Wisconsin Department of Transportation

Proposal #29: 9090-01-61, WISC 2020 156
Eagle River - Tipler
Divide Rd To STH 55 Culverts
STH 70
Forest County

This is Addendum No. 03, which provides for the following:

ADDENDUM NO. 03
9090-01-61 & 9090-01-72
April 7, 2020

Addendum No. 03
ID 9090-01-61
Added Sheet 4A
April 7, 2020

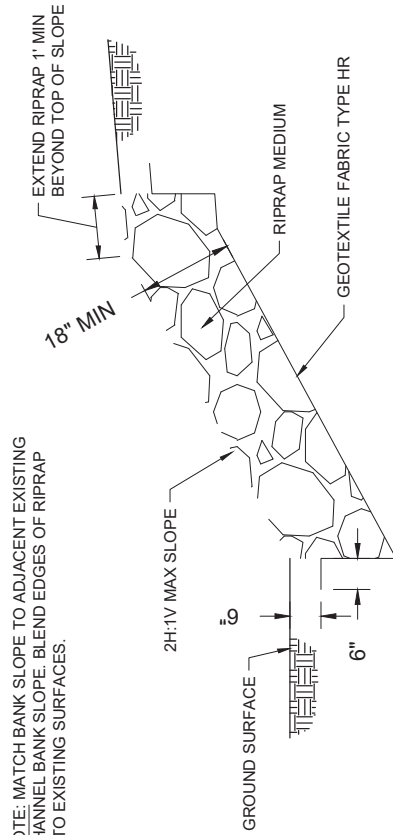
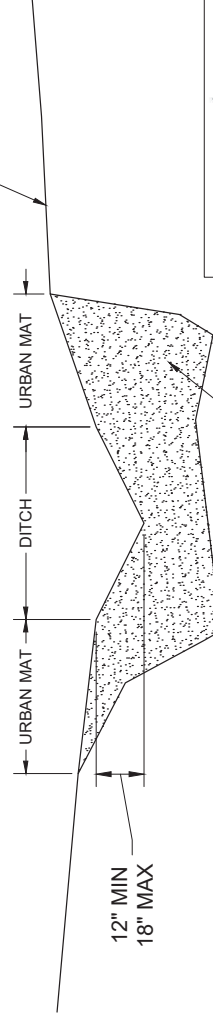
Added Plan Sheets – Project 9090-01-61	
Plan Sheet	Plan Sheet Title (brief description of why sheet was added)
4A	Typical Sections; added typical road section at improvement, riprap channel bank typical section and ditch and channel in-fill typical section
4B	Headwall Details; added notes and details for concrete endwalls
4C	Survey Control Plan; provides control points for culvert replacement
4D	Diversion Plan – Culvert 21070073753; provides water diversion information, temporary erosion control measures and wetland impact areas
4E	Culvert Plan – 21070073753; provides required construction information for culvert replacement
16A	Miscellaneous Quantities; denotes quantities for added work
99A	Cross Sections; existing and proposed road cross sections near culvert replacement
99B	Cross Sections; proposed road cross sections near culvert replacement
99C	Cross Sections; proposed road cross sections near and along centerline of culvert replacement

NOTE: PROVIDE DITCH WHERE SHOWN ON THE PLANS. EXCAVATE EXISTING GROUND AS NEEDED. DITCH SIDE SLOPES SHALL BE 2H:1V. LINE DITCH WITH EROSION MAT CLASS II TYPE C. COVER IN-FILL WITH EROSION MAT URBAN CLASS I TYPE B.

FILL ABANDONED CHANNEL WHERE SHOWN ON THE PLANS. CONTOUR TO MATCH SURROUNDING GROUND SURFACE

Addendum No. 03
 ID 9090-01-61
 Added Sheet 99D
 April 7, 2020

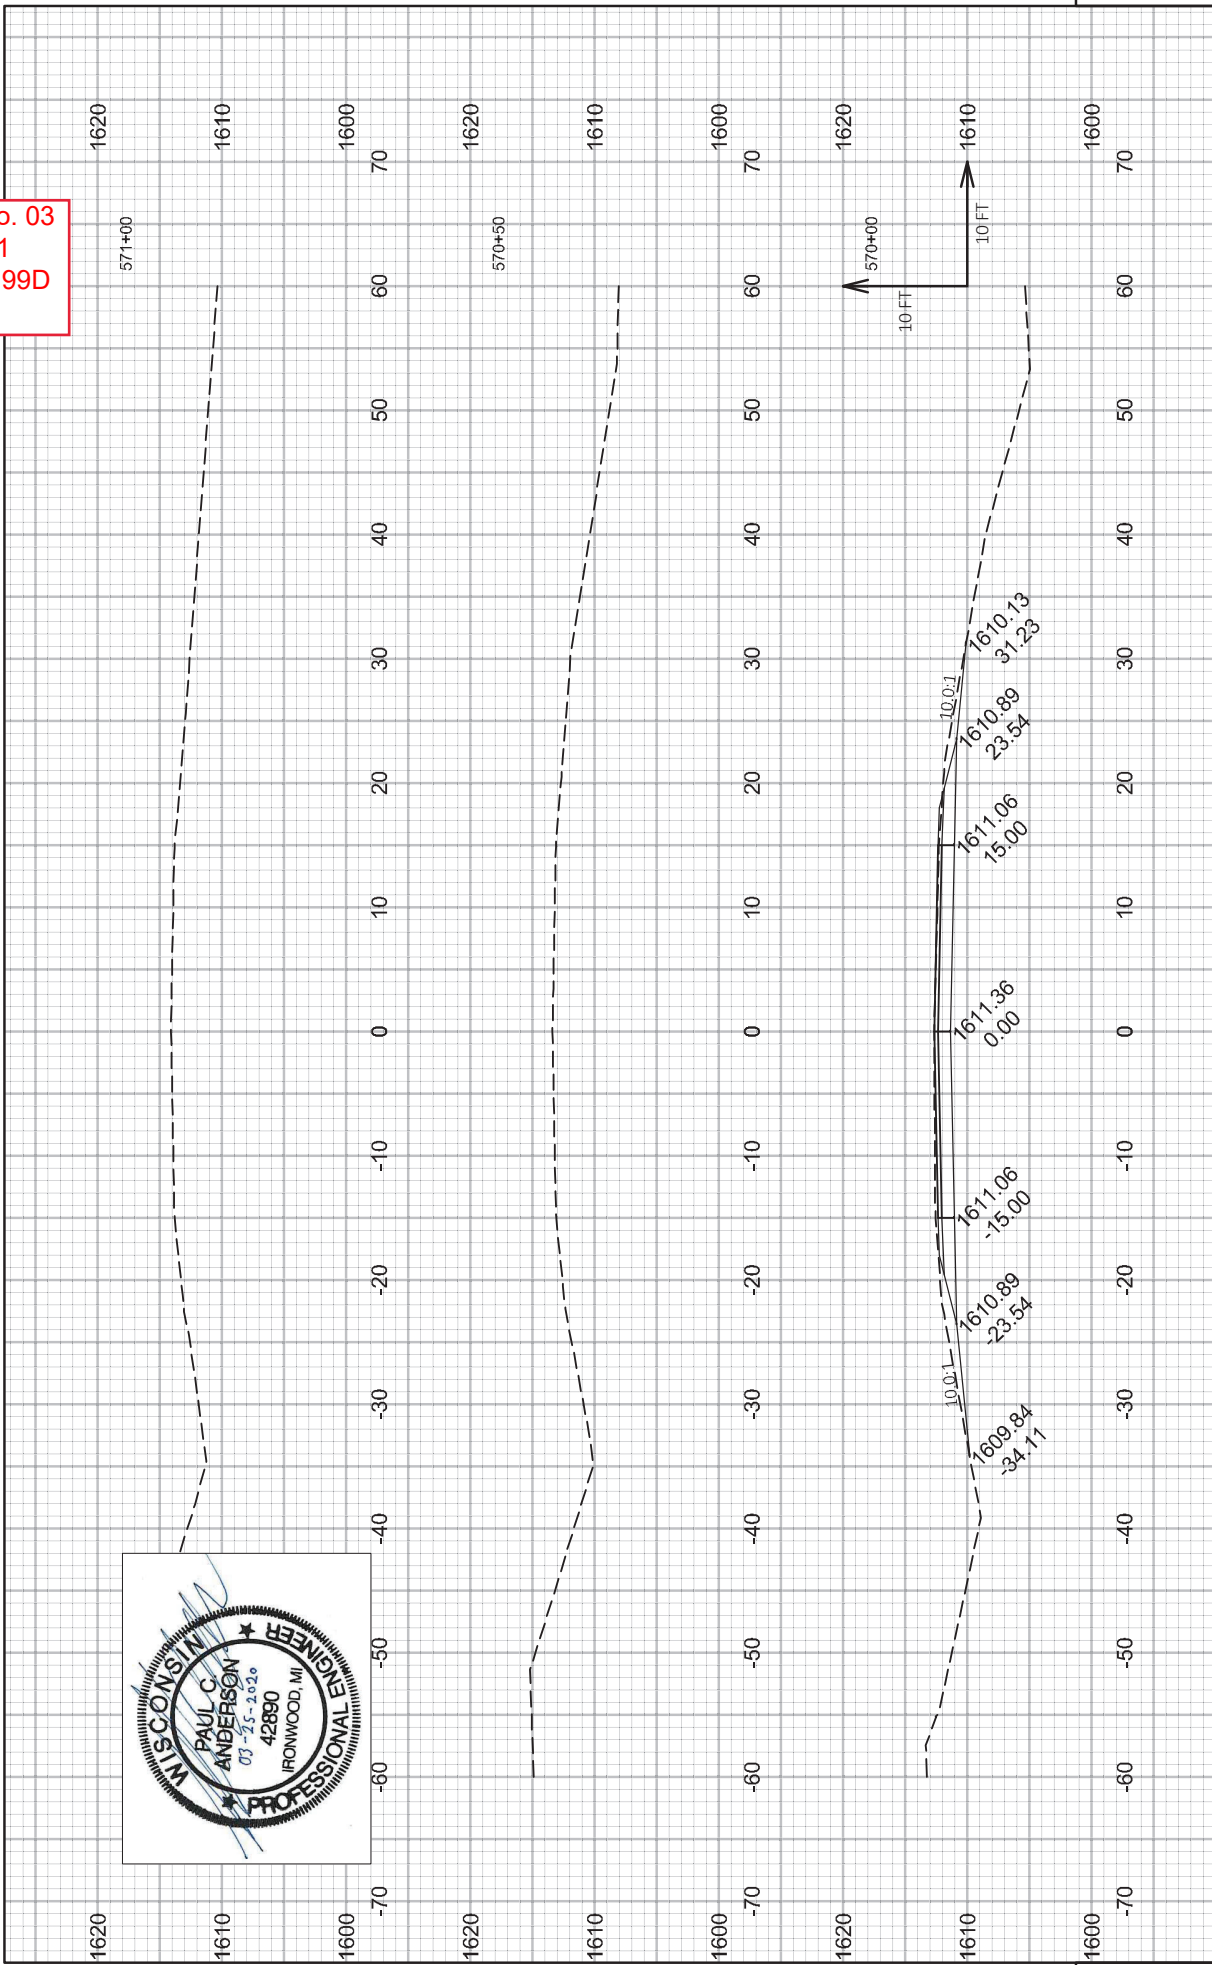
99D	Cross Sections; existing and proposed road cross sections near culvert replacement
